POTENTIALLY UNQUALIFIED COMPONENT IN CERTAIN ALLEN BRADLEY TIMING RELAYS

Part 21 Report No: P21-04302015

Subject: Report of potential 10CFR Part 21, Allen Bradley Timing Relay Model 700RTC

Figure 2 - New design circuit board and CPLD that replaced the original component.

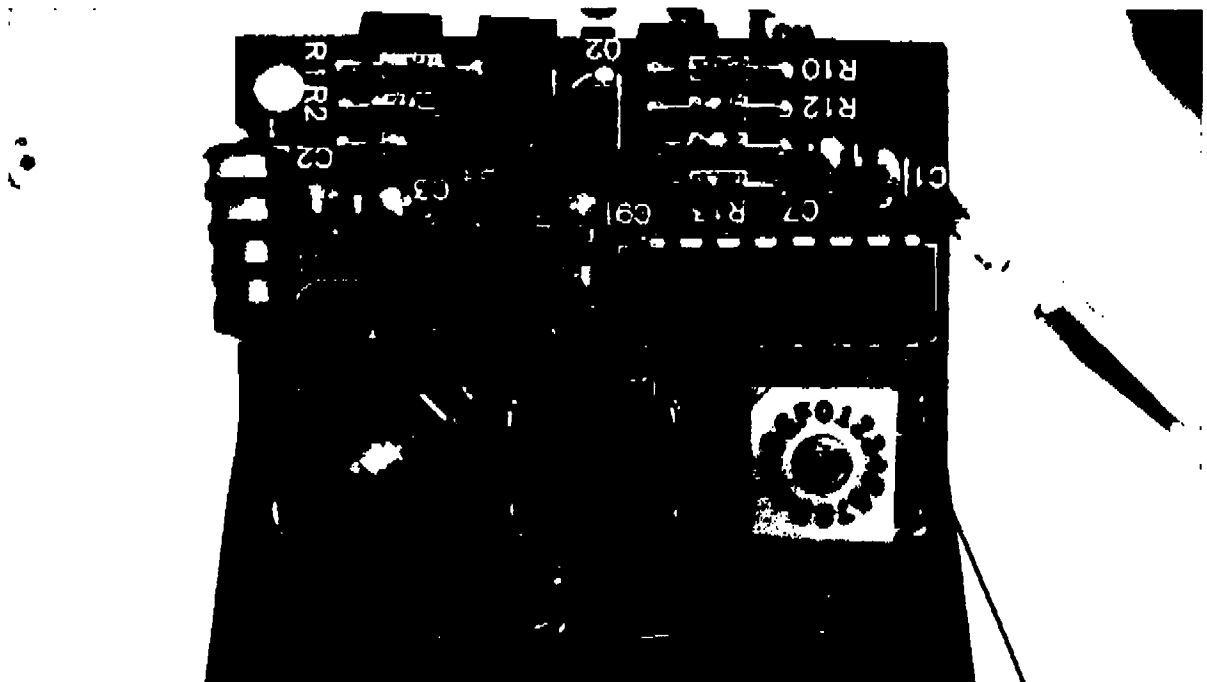
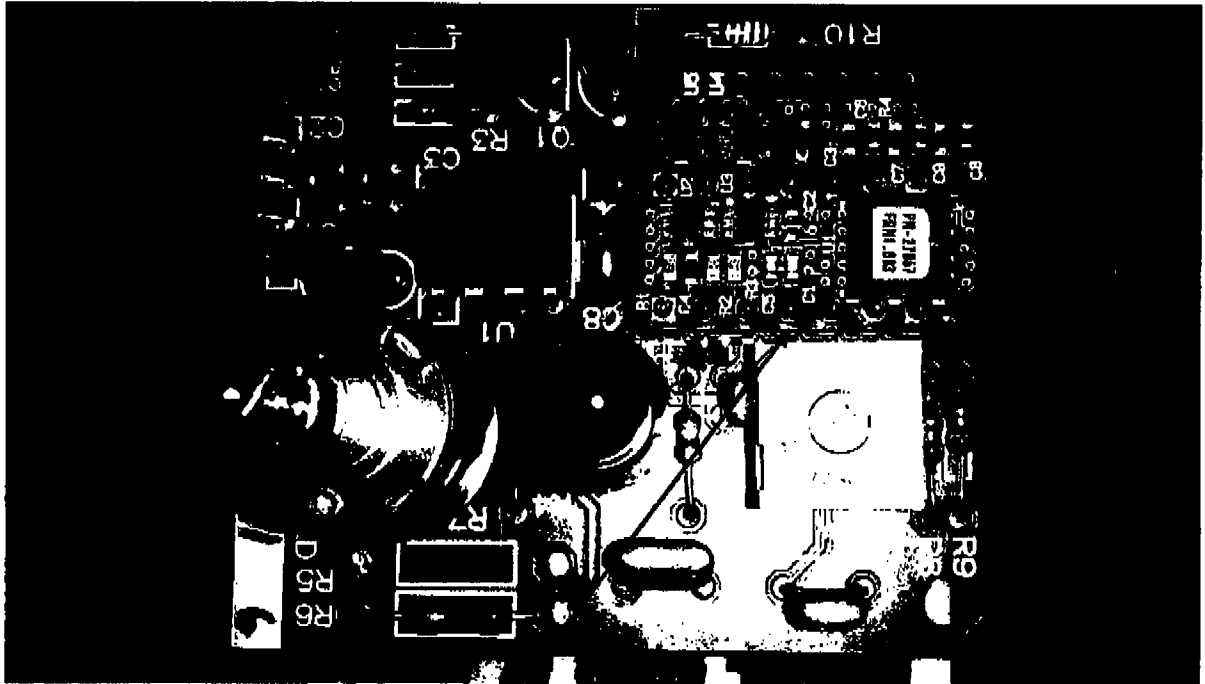
Between 2009-2010 Allen Bradley made a design change without changing the part number of the commercial relay or providing any documented evidence of a design change. The manufacturer specification data sheets maintain the classification that the relays are "solid state", which would imply that there are no digital devices installed in the relay. However, after inspection of the internals of the timing relay (Figure 2), it has been identified that the unit does contain a CPLD which meets the definition of a digital device under the guidance of NEI 01-01. See Figures 1 and 2 below:

Figure 1- Original qualified design (prior to 2009).
Relays supplied prior to 2009 are not affected by this issue.

The relays that are currently in stock at NLI have been placed on hold until after the units have been qualified for the specific application. NLI will perform EMC qualification testing per the requirements of EPRI TR-102323 Rev. 3 for the following tests, as applicable: CE101, CE102, RE101, RE102, RS101, RS103, CS101, CS114, CS115 and CS116. Estimated completion date is August 28, 2015.

The relays are dedicated for generic application usage in timing applications. The specific plant application(s) is unknown by AZZ. The EMC qualification of the relay is dependent on the installed configuration and location in the plant. The plant should evaluate whether the installed relays are subjected to unevaluated EMI/RFI conditions in the plant.
